# Gloucestershire

Please find attached the Gloucestershire County Council Conservative group submission in response to the draft recommendations for division boundaries in Gloucestershire.

Gloucestershire County Council  
Conservatives  
Boundary review consultation submission

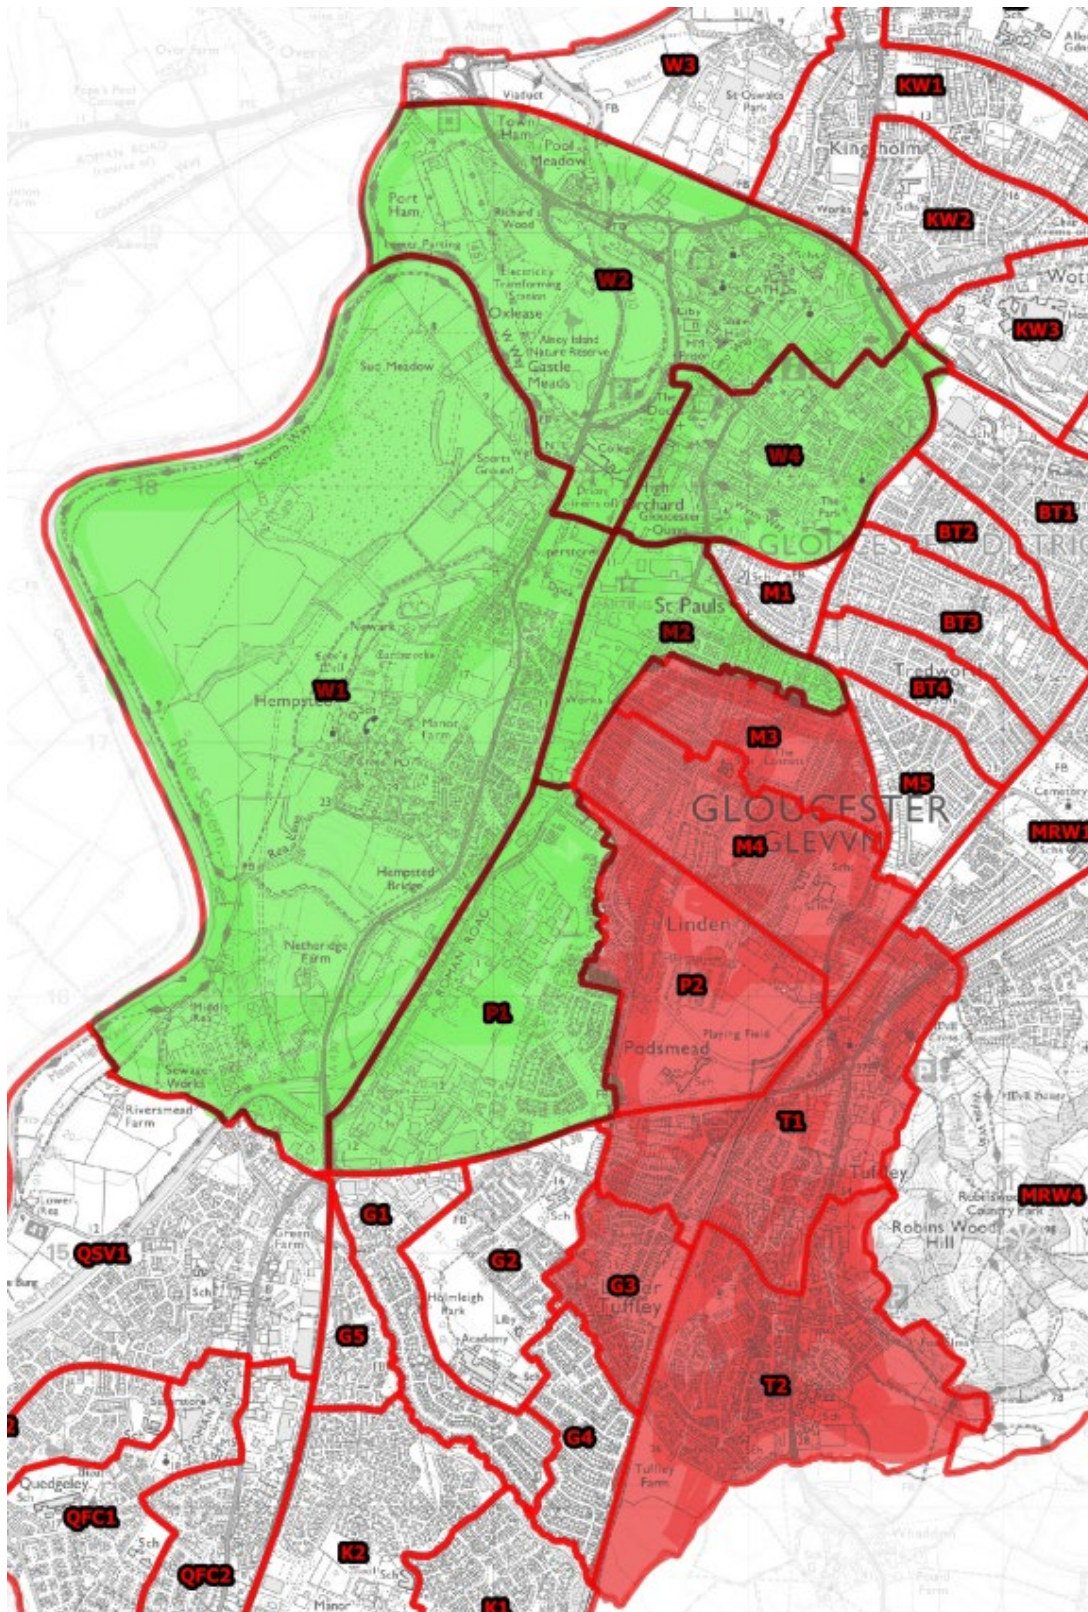
### P2 out of Hempsted & Westgate and into Tuffley

P2 contains several key locations that are very important to residents represented in the current Tuffley ED including Tuffley Park, the second largest green space in the division, a local school attended by many constituents in the Tuffley ED and sports centres synonymous with the area. Many constituents of P2 also regularly use St. Barnabas Church, just over the boundary in T1. These residents therefore have a strong local identity as part of Tuffley and therefore to divide this division in such an artificial way would negative effect local community cohesion and electoral representation. These residents are best served by a county councillor who represents not just their home, but the locations of fundamental

We also note that should Tuffley ED lose P2 the division's geography would not be continuous. It would mean that a large chunk in the middle of the division would have a different Councillor, which may lead to confusion for residents and leave them feeling disconnected. This is particularly acute in the east of the polling district where residents in New Dawn view would end up with a different Councillor to those directly across the road from them and immediately over them railway line, despite all using the same community spaces and facing common issues. A Councillor for Hempsted & Westgate would be unlikely to resonate with these constituents' issues and, historically, councillors for this area tend to live in the north of the division meaning they would be geographically far removed from constituents.

We make a similar argument for the continued inclusion of M2 in the Hempsted and Westgate ED. Retaining this polling district is important to the cohesion and identity of Hempstead & Westgate. M2 shares many of the same local issues as the rest of the division (particularly the east of W1) - particularly around environment, facilities used by constituents and employment. These are not issues shared by the rest of Tuffley division.
